6-I-20-HZ
APPLICATION FOR CERTIFICATE OF APPROPRIATENESS

424 E. Scott Ave. 37917
Old North Knoxville H-1

Staff Report - Certificate of Appropriateness Application

File Number: 6-I-20-HZ

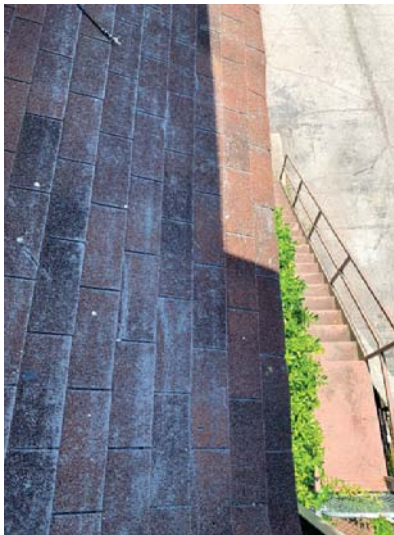
3. The basement-level window is not a character-defining feature of the house and is not visible from the public right-of-way. Replacement of the window with a secondary access door, including a modestly-sized access platform is appropriate. Applicant should submit the door specifications and details on the proposed door design and guardrail for staff approval.

Staff recommend approval of the work as proposed, with the following conditions: 1) use type O mortar to repoint historic masonry sections, unless documentation is provided to staff that the sections to receive repointing are modern brick; 2) proposed replacement door and platform railing details to be reviewed by staff; 3) a metal roof be selected that better resembles historic standing seam metal originally found in the neighborhood, with a color to meet design guidelines, with approval by staff
